Regional Review Finding Development of Regional Impact

RE: Development of Regional Impact (DRI) Review

Name of Proposal: Cascade Palmetto Highway and Ridge Road DRI 4371

DRI - METHODOLOGY MEETING PACKET SITE PLAN

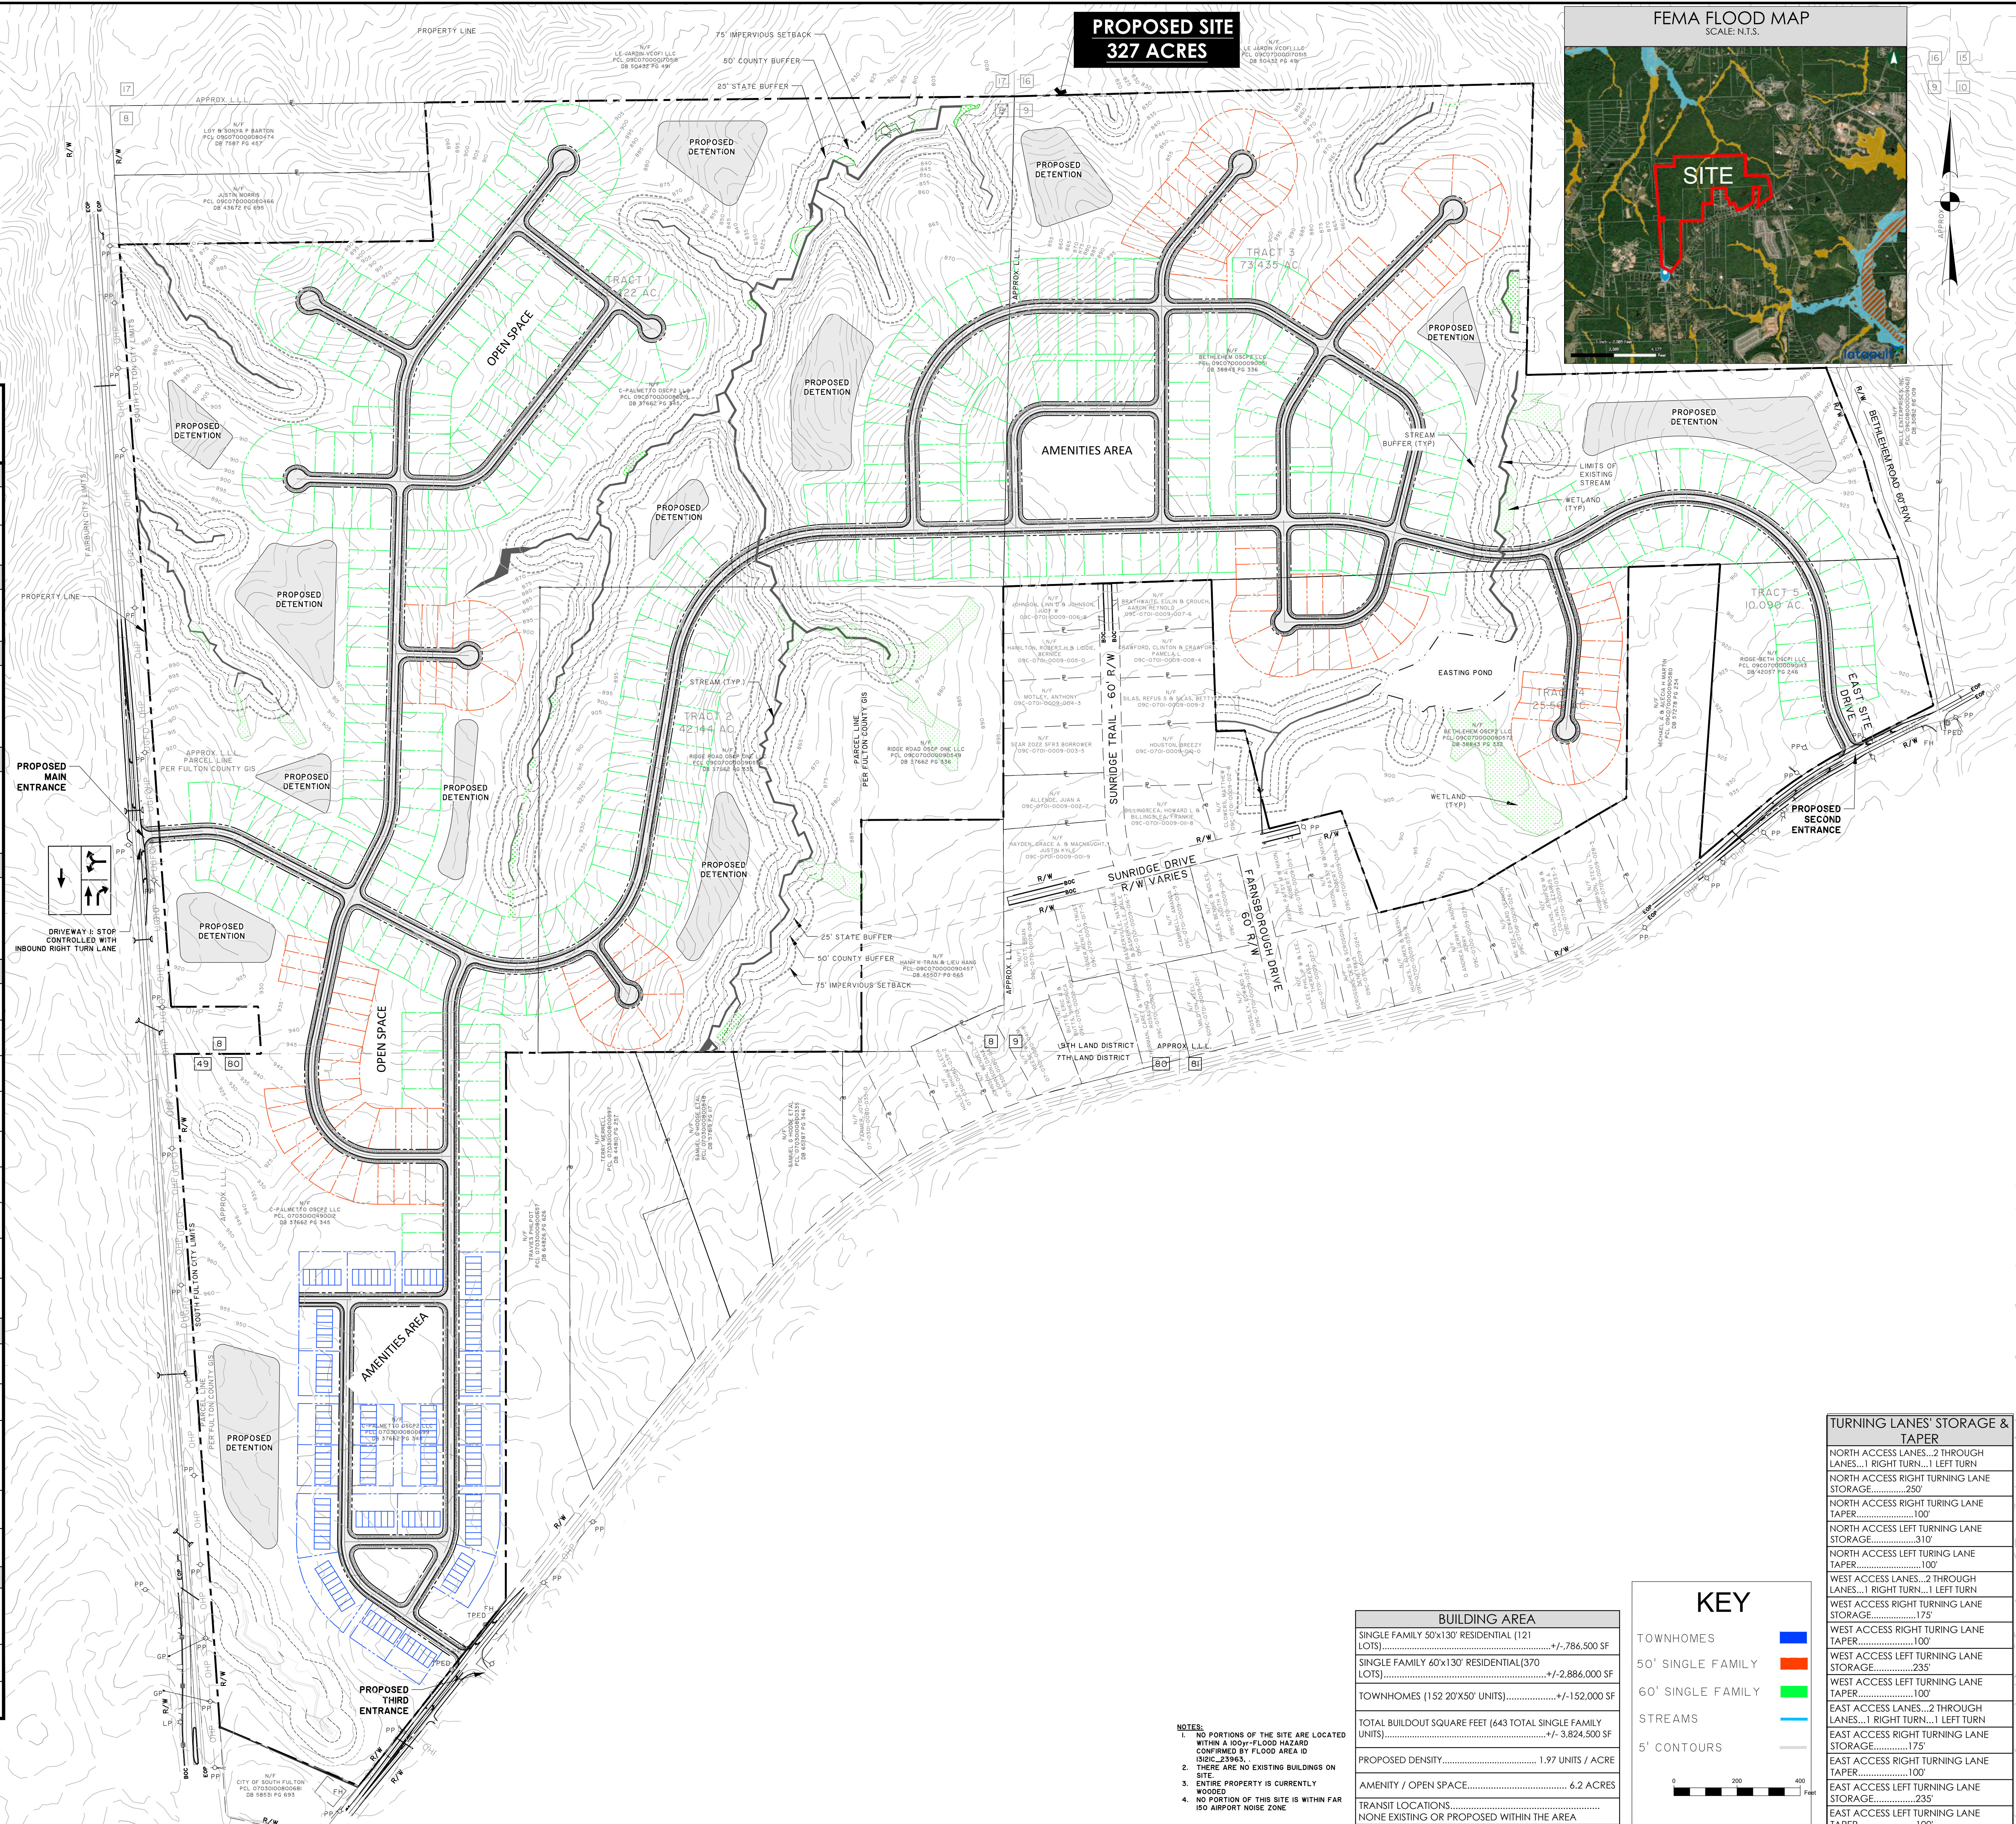
The project generally utilizes a winding curvilinear street layout terminating in cul de sacs. While this approach is partially warranted by need to reduce conflicts with protected streams, utilizing some aspects of a grid layout could would enhance connectivity.

The proposal is largely consistent with ARC's MTP. The project uses promote multimodal transportation usage and impacts along a Regional Truck Route have been accounted for. Though there are connective sidewalks throughout the site, there is a lack of crosswalks. Biking accommodations connecting to the nearby Silk Sheets bike route should be considered.

The submitted site plan shows two unnamed tributaries to Town Creek flowing from south to north: one in the center of the project property and one in the eastern side of the property, both with several branches extending from them. The site plan also shows two shorter unnamed tributaries to Town Creek along the northern edge of the property and two unnamed tributaries to Tuggle Creek on the west side of the property. The USGS coverage for the project area shows only tributary to Town Creek at the center of the property. The submitted site plan shows and identifies the State 25-foot Erosion and Sedimentation Buffer as well as a 75-foot impervious setback and 50-foot undisturbed buffer on all streams on the property, which meets the requirements of the City's stream buffer ordinance (City Code Chapter 17), and is consistent with the Metropolitan North Georgia Water Planning District's stream buffer requirements. The only intrusions shown on the submitted site plan are two transportation stream crossings, which are allowed under the City ordinance. No residential lots or several stormwater management areas and a mailbox kiosk area are shown intruding into the impervious setbacks. Any intrusions into City buffers or setbacks may require a variance from the City.

No floodplains are shown on the submitted plans. The FEMA coverage for the area shows an area of 500-year floodplain along the unnamed stream at the center of the property. No 100-year floodplain or floodway areas are shown. One road crossings is the only intrusion in the 500-year floodplain shown on the submitted plans.
